ABERDEEN SECOND ADDITION

TO WICHITA, SEDGWICK COUNTY, KANSAS

RE: S/D 96-18, Final Plat of the ABERDEEN 2ND ADDITION

RE: S/D 96-18, Preliminary Plat of the ABERDEEN 2ND ADDITION

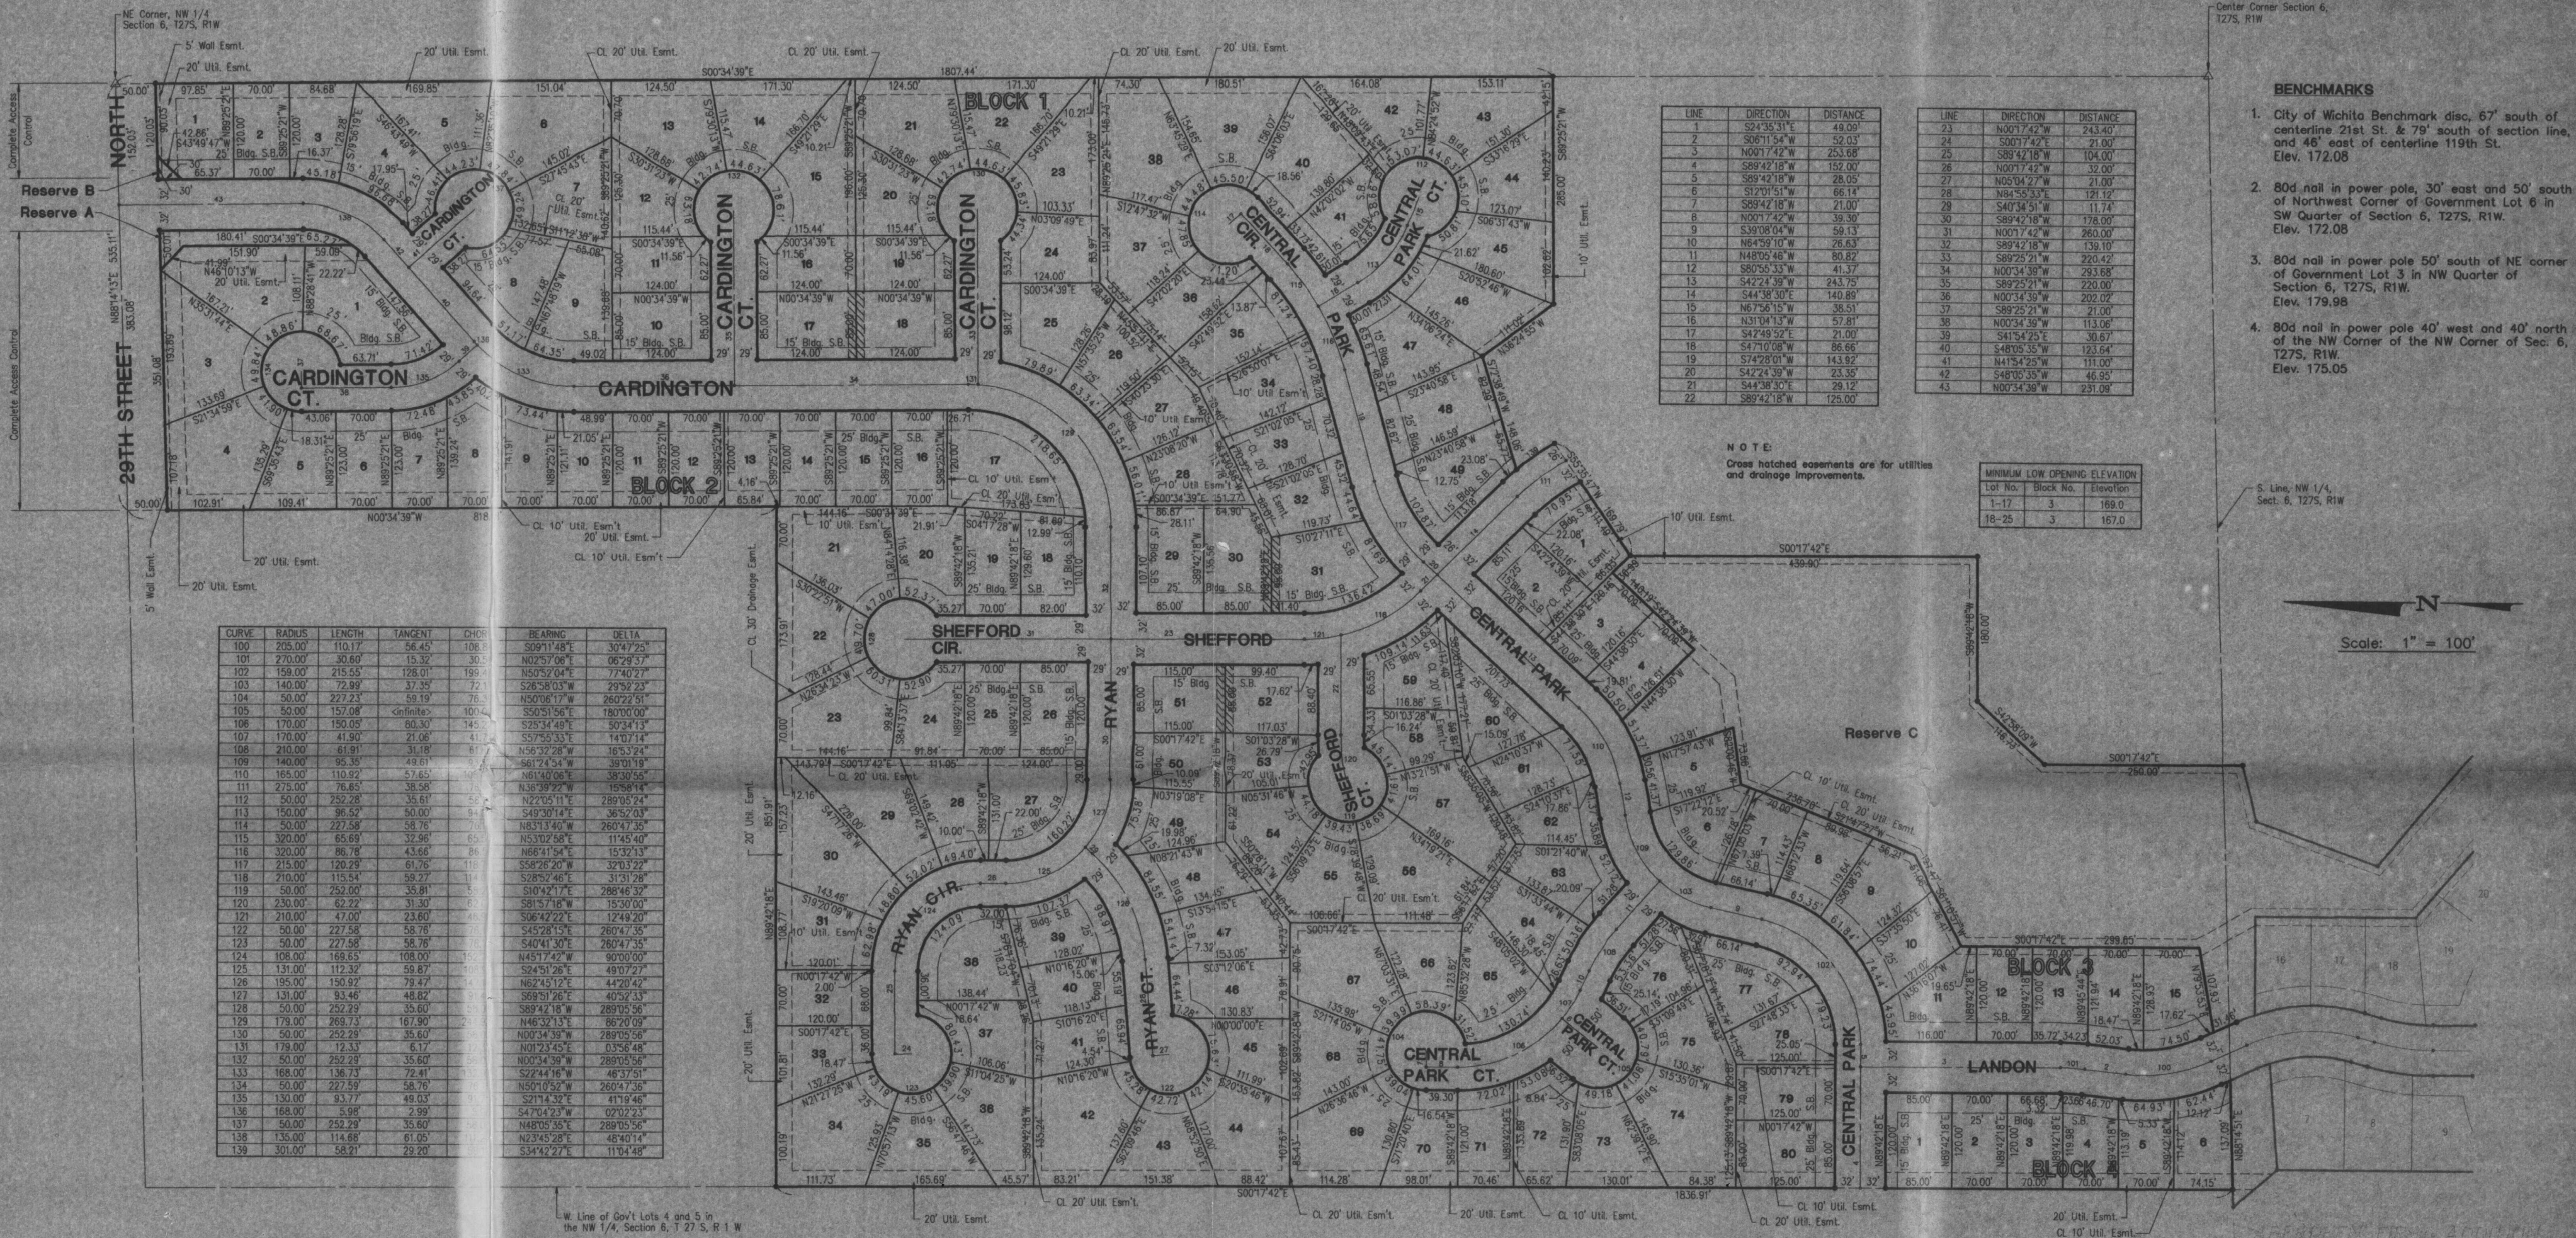
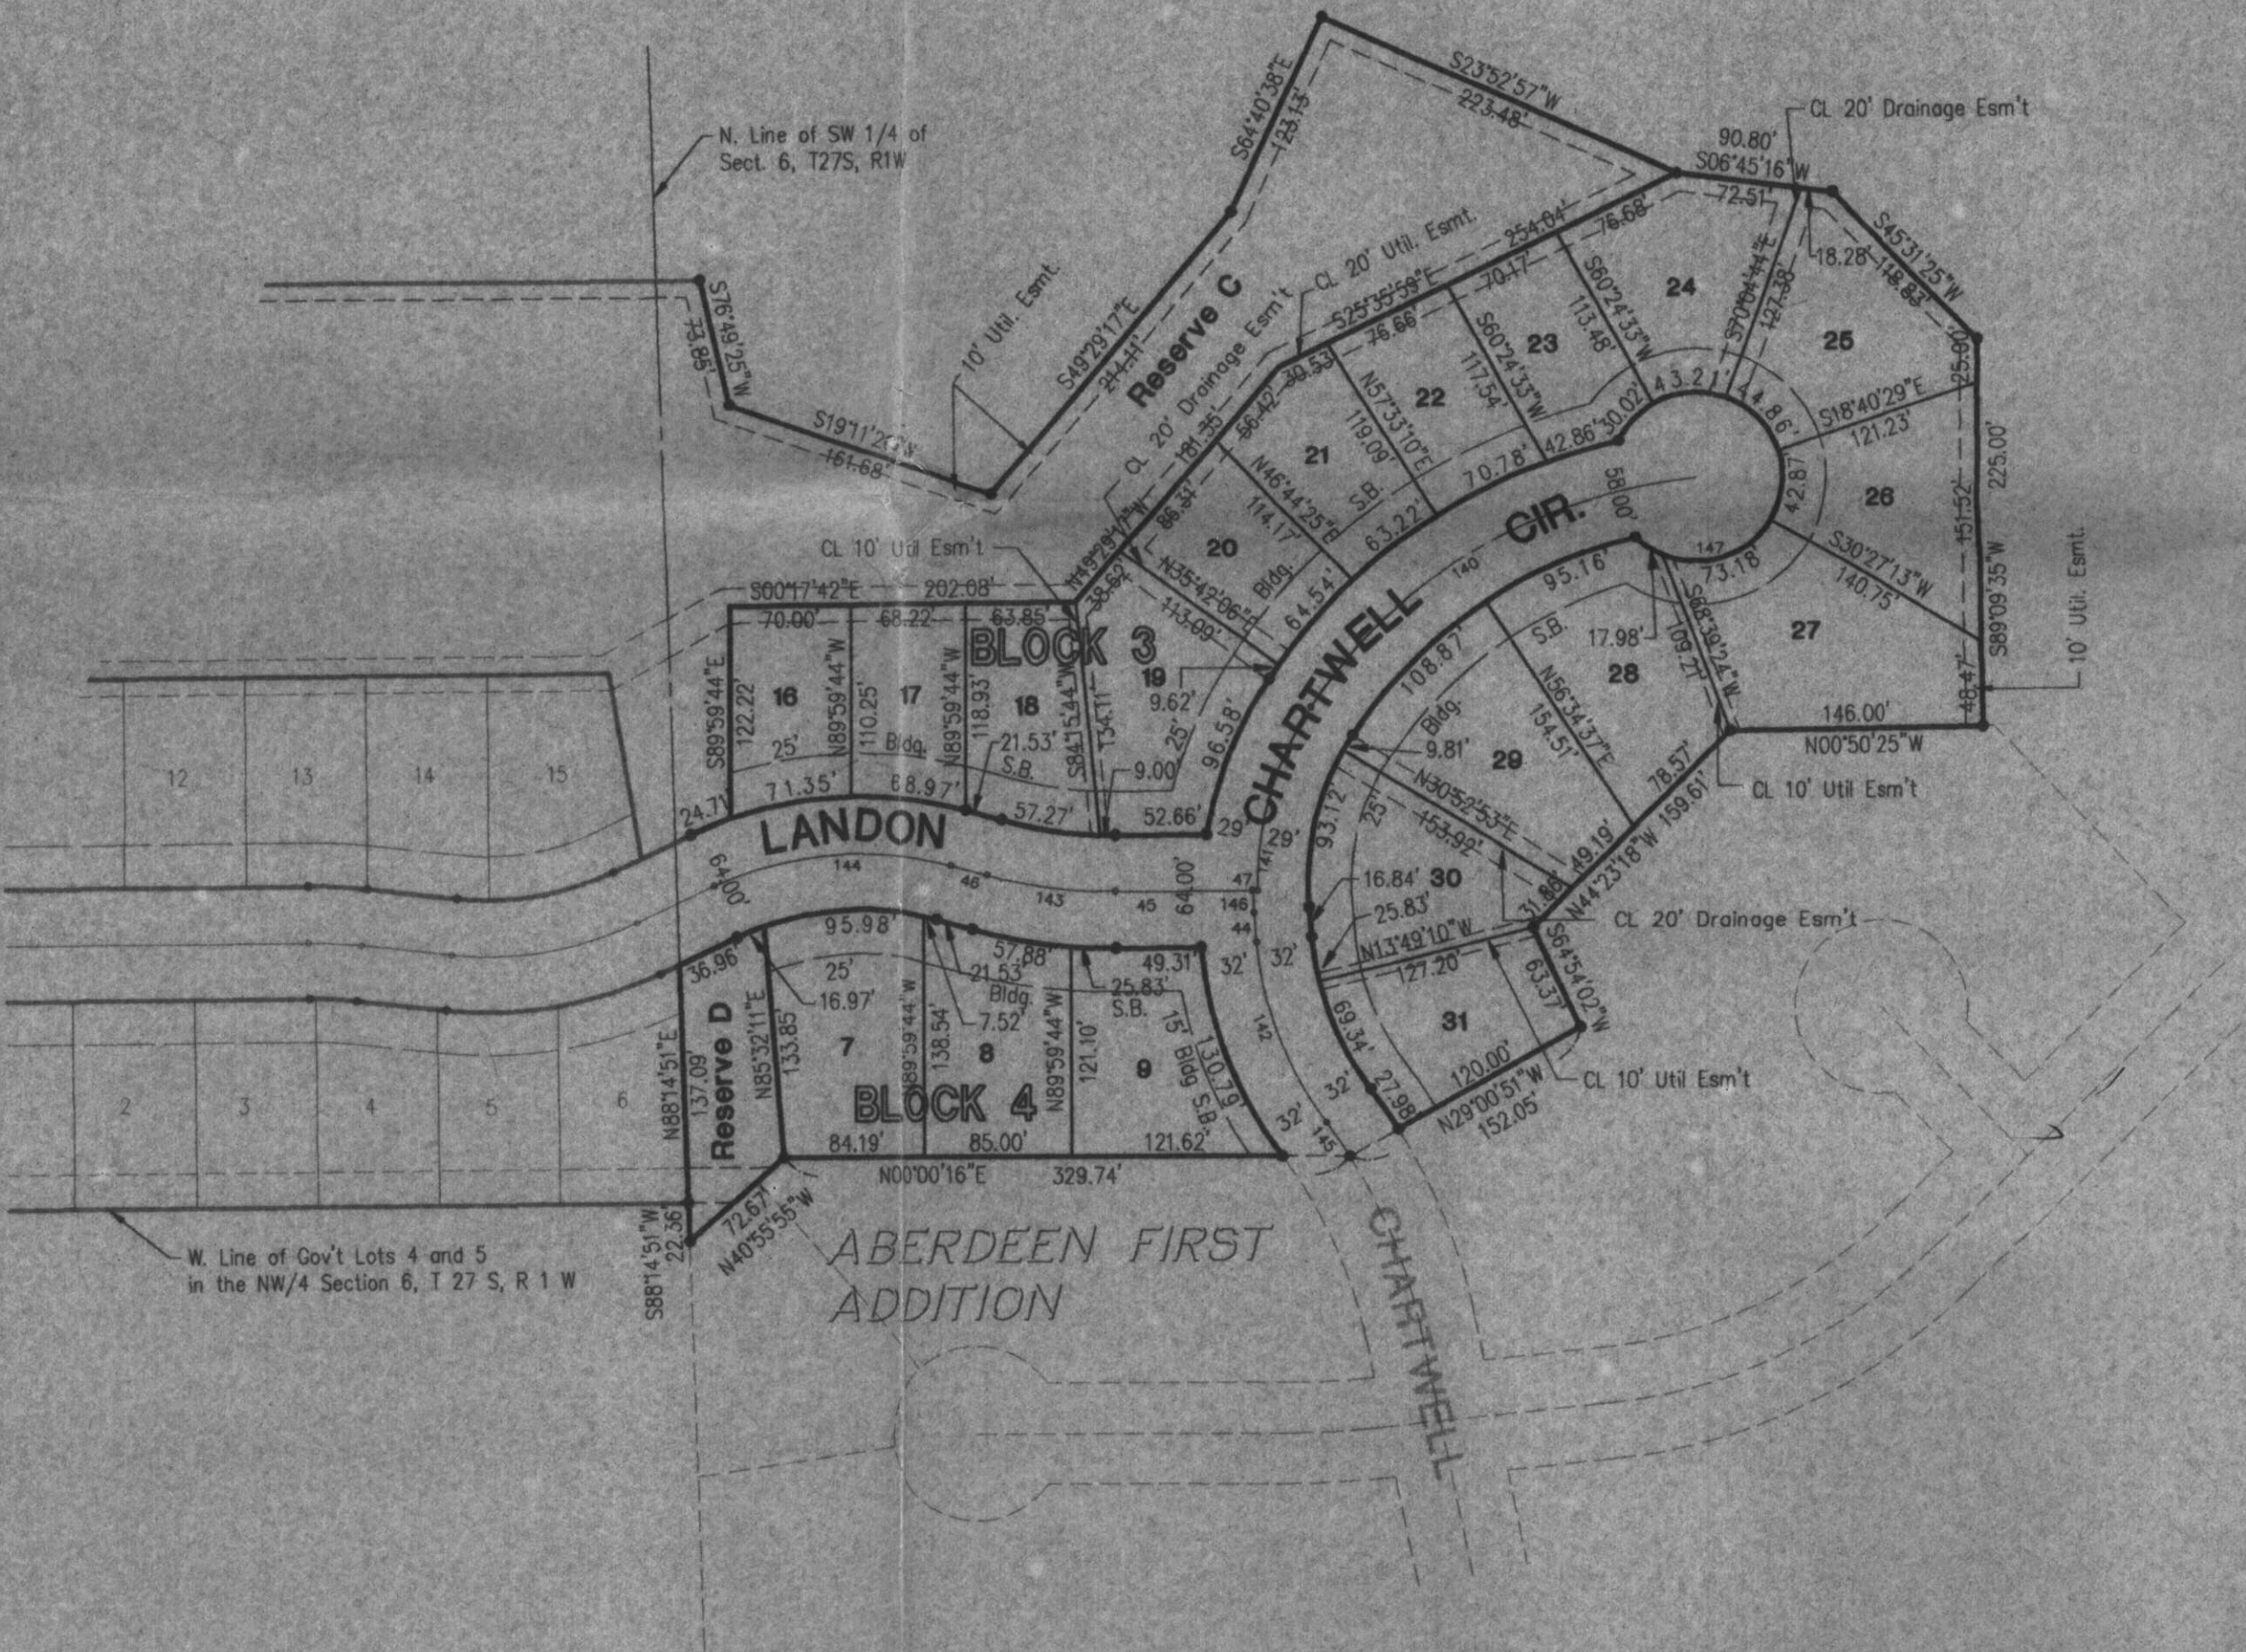
- M. Since this property will need to establish minimum building pad elevations, the face of the plat shall reference the location and elevation of permanent on-site and off-site benchmarks. Section 5-402(N).

- N. The platting of the minimum building pad elevations shall be noted on the face of the final plat tracing as well as in the plat's text.
- O. The applicant shall submit a covenant which provides for four (4) off-street parking spaces per dwelling unit on each lot which abuts a 58-foot street. The covenant shall inventory the affected lots by lot and block number and shall state that the covenant runs with the land and is binding on future owners and assigns.

- Q. On the final plat tracing, as indicated by the platlor's text, a utility easement shall be provided within Reserve B.
- R. On the final plat tracing, dashed lines shall be used where the streets (Chartwell, Central Park, etc.) terminate at this plat's perimeter. Solid lines are used to indicate private streets.

- Y. The final plat shall indicate the utility easements requested by K.G. & E. which are indicated on the enclosed "marked" copy of the plat.
- Z. As noted by City Engineering, prior to submitting the final plat tracing for City Council review, additional information will be needed in regards to this site's drainage plan. Also, the applicant shall confirm if this site is impacted by high ground water levels and if necessary building pad elevations will be required for any such lots.
